WSU Bankstown Campus Proposal Peer Review of Transport and Traffic

Prepared for:
Canterbury-Bankstown City Council

13 September 2019

Peer Review of Transport and Traffic

Figure 15 Existing travel to work mode share (DZN 115710002)

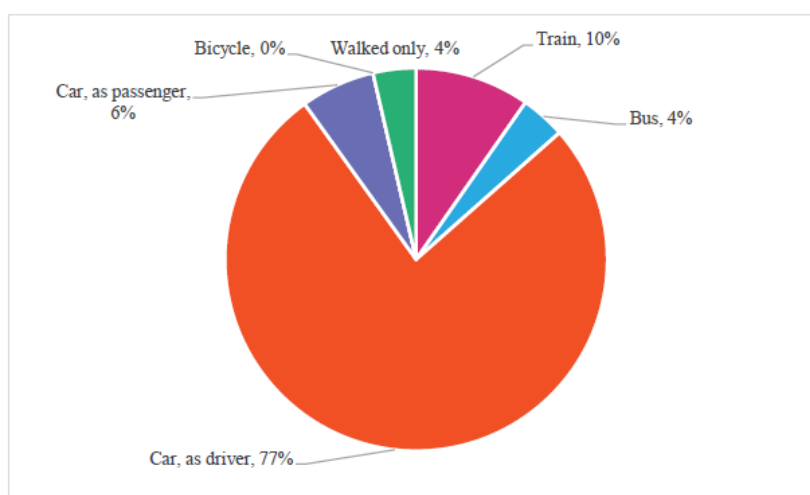
- Year 2016 Census data presented in Figure 15 of the TMAP indicates that 83 per cent of trips made by people employed within the selected Bankstown destination zone are car-based (77 per cent as car driver and 6 per cent as car passenger trips). Public transport only accounts for 14 per cent of trips, with the remaining four per cent by walking.

- The above data indicates that the Bankstown area is very reliant on car usage, even though the area is serviced by good public transport services, including rail and bus services from Bankstown Station.
- The Sydney Metro between Bankstown and the City will operate from Year 2024 at a peak frequency of 15 trains per hour in both directions (1 every 4 minutes). On this basis, it is expected that there would be some modal shift to train/metro once the Sydney Metro is operational.

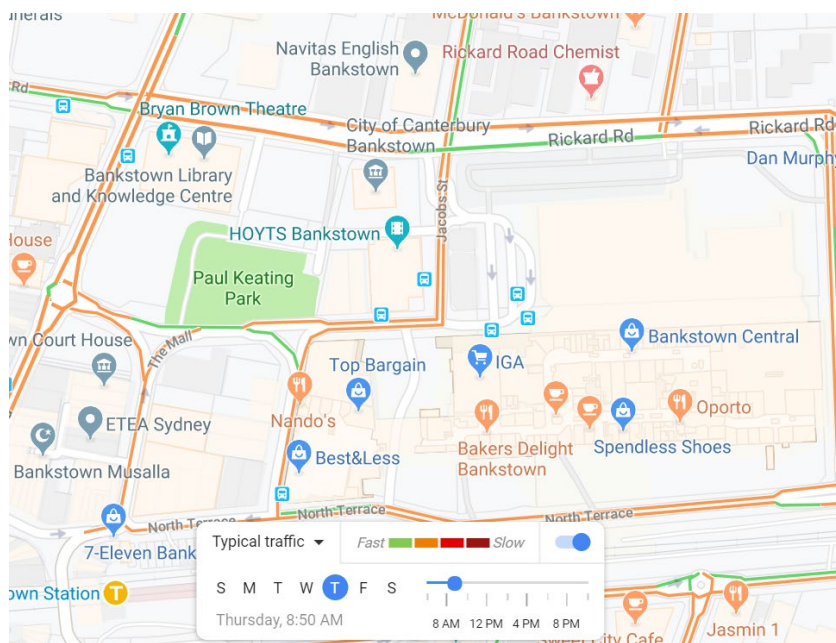
- Traffic surveys were undertaken at the two key immediate intersections on Wednesday 5 September 2018 between 7am and 10am and between 3pm and 7pm, as follows:
 - Rickard Road / Chapel Road
 - Rickard Road / Jacobs Street
- Traffic modelling was undertaken using SIDRA 8 modelling software at the above two intersections to assess existing conditions and future traffic conditions (including the full development of the site and traffic growth). A future background growth of 2.5 per cent on Rickard Road in the AM peak has been adopted in the traffic assessment based on future mid-block traffic volumes from the draft Bankstown Complete Streets project.

- Based on the modelling outputs, only Year 2018 has been assessed (i.e. no future year scenario). It is recommended that a +5 or +10-year future case scenario be assessed with and without the proposed development.

Typical Thursday AM at 8:50am

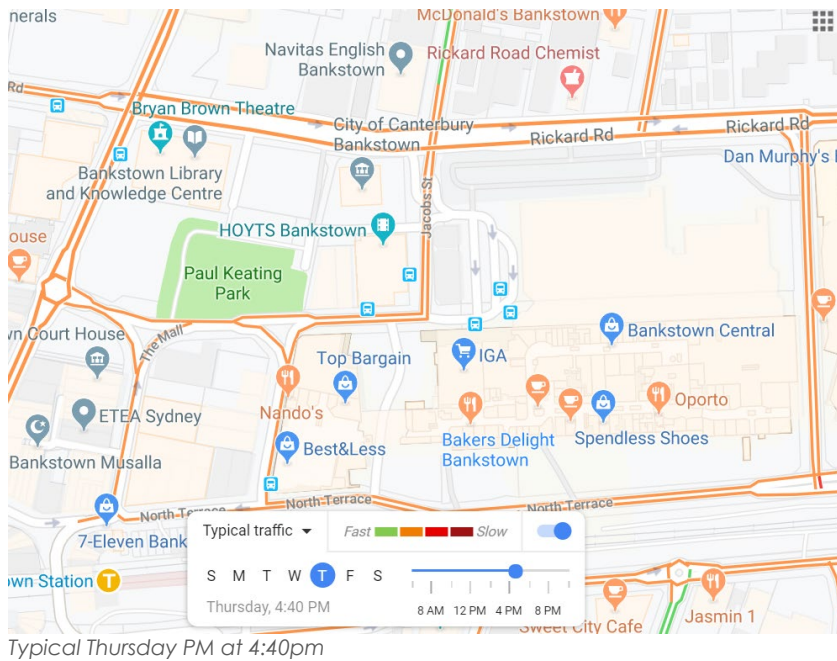
- No queue length data is provided. It is recommended that queue length data is collected to assess the validity of the traffic models.
- Analysis of google congestion maps indicate that speeds along Rickard Road are not “free flowing” but with some congestion during the AM and PM peak periods. This data is generally interpreted as traffic queues for practitioners in the absence of queue length data. The orange line denotes that travel speeds are less than the posted speed limit, such that queues are interpreted as half the length of the orange line. Therefore, this suggests that the queue lengths modelled do not match the google congestion map data. See below.

Figure 37 Car park access and egress routes and distribution

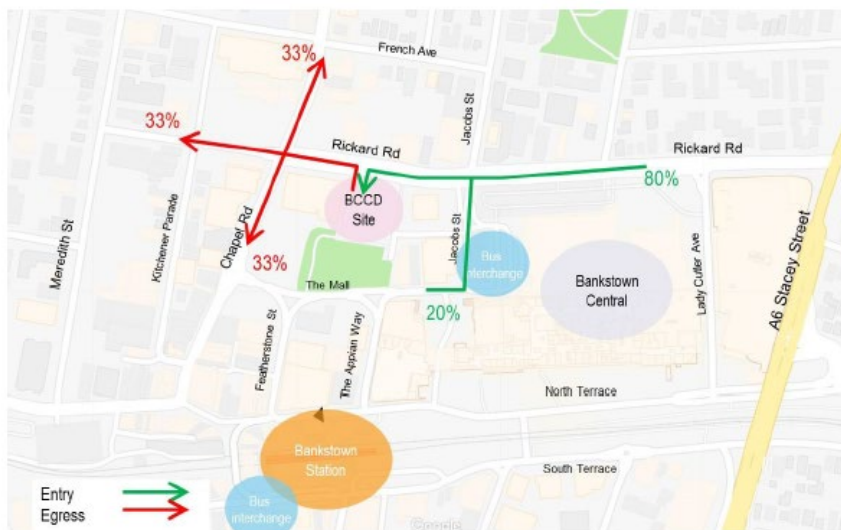
- The traffic distribution and assignment of traffic assumes that the majority (80 per cent) of traffic accessing the car park will arrive via Stacey Street and Rickard Road, with the remainder arriving from Jacobs Street and Rickard Road, as shown in Figure 37. Traffic leaving the site has been assumed to be evenly distributed north, west and south at the Rickard Road-Chapel Road intersection.

Figure 38 Set-down access and egress routes and distribution

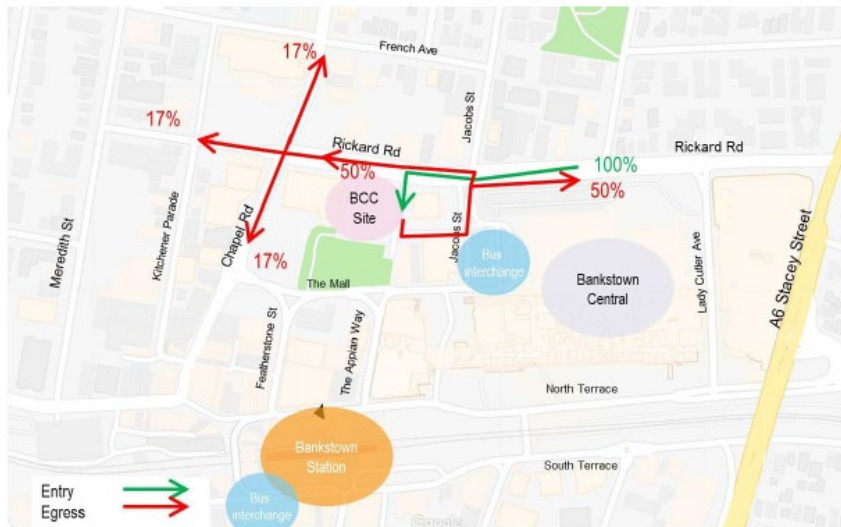
- The traffic distribution and assignment of traffic assumes that all drop-off traffic will arrive from Rickard Road (i.e. westbound through at the intersection with Jacob Street), whereas 50 per cent of vehicles will exit the site eastbound and 50 per cent of vehicles will exit the site westbound on Rickard Road, as shown in Figure 38.

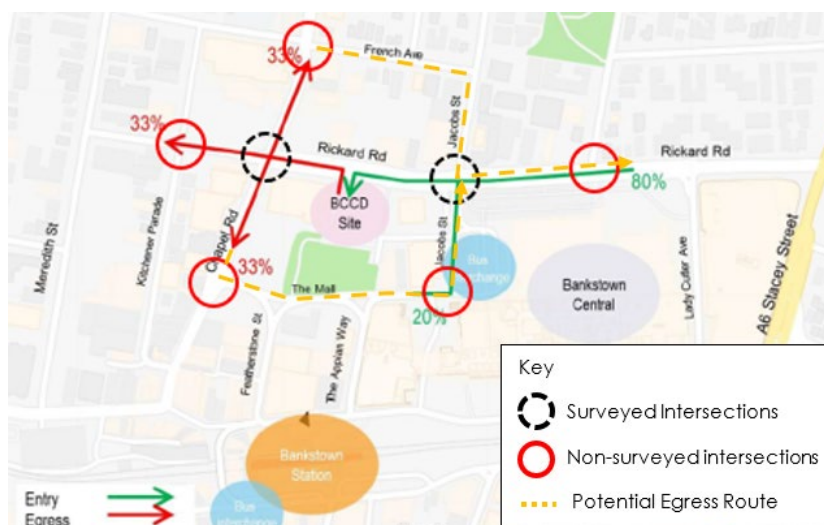
- It is expected that the proposed development would generate some additional traffic onto surrounding intersections, including the following:
 - Chapel Road-The Mall (roundabout)
 - Rickard Road-Kitchener Parade (signalised intersection)
 - French Avenue-Chapel Road (signalised intersection)
 - Rickard Road-Sir Joseph Banks Street (signalised intersection)
 - The Mall-Jacobs Street (priority intersection).

No traffic surveys or modelling has been undertaken at the above intersections. The above intersections are circled red, with the surveyed intersections shown in black in the following figure. It is noted that the intersection impacts at the Rickard Road-Jacobs Street intersection could potentially be exacerbated as a result of motorists (egress) wishing to turn back onto Stacey Street, as shown in orange dashed line below.

Figure 27 Pedestrian access points

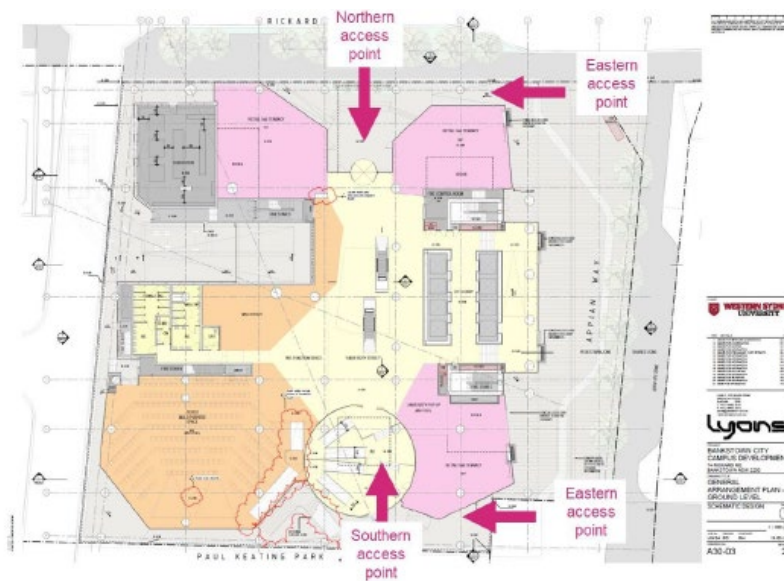
- The proposed pedestrian access to the campus is considered acceptable, with key pedestrian access points to the site shown in Figure 27 along the north, east and south portions of the site.

Figure 28 Proposed staff bike parking

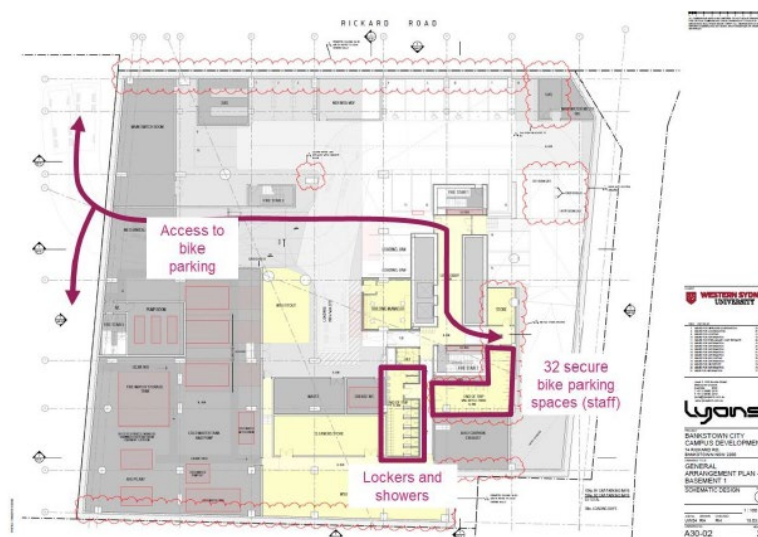
- Access to the staff bicycle parking area in the basement (32 spaces) will be provided via the driveway or lifts. The ramp grades are not outlined on the architectural plans, but it is understood that the driveway has been designed to accommodate vehicles up to and including an 8.8m medium rigid vehicle. For an 8.8m medium rigid vehicle, a maximum ramp grade of 1:6.5 (15.4%) is permitted under AS2890.2:2002. Generally, longitudinal gradients on paths for cycling should be as flat as possible.

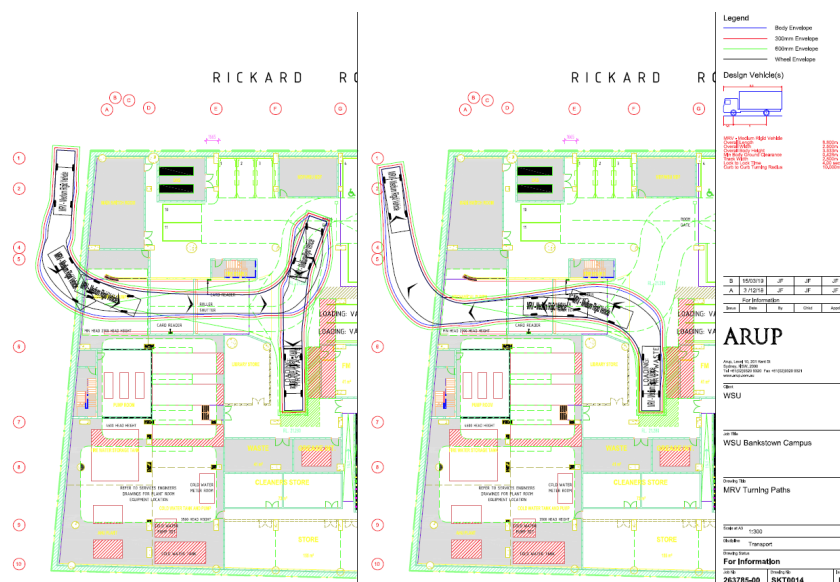
- A loading dock is proposed within the basement to allow for one 8.8m long medium rigid vehicle/waste vehicle and two courier vans. Further clarification on the anticipated servicing demand and frequency of the proposal, including the type of service vehicles expected, is required as part of any future development application for the site to further assess the adequacy of the loading dock.

- TPP notes that other educational facilities generally design for a 12.5m heavy rigid vehicles (such as at UTS, ACU, Meadowbank TAFE). Therefore, further clarification is required to justify the proposed loading dock provisions. However, it is not unreasonable to restrict service vehicles to an 8.8m medium rigid vehicle or smaller, subject to the provision of management measures (e.g. signage, line marking or a loading dock management plan).

- A loading dock management plan is recommended for the proposed development to ensure all deliveries to the site are appropriately managed throughout the day. The loading dock management plan will need to include measures that specify that deliveries to the site are to be undertaken only during an allocated time slot and booked in advance with the loading dock manager. The loading dock management plan should be prepared in consultation with Council and be conditioned as part of any development approval.
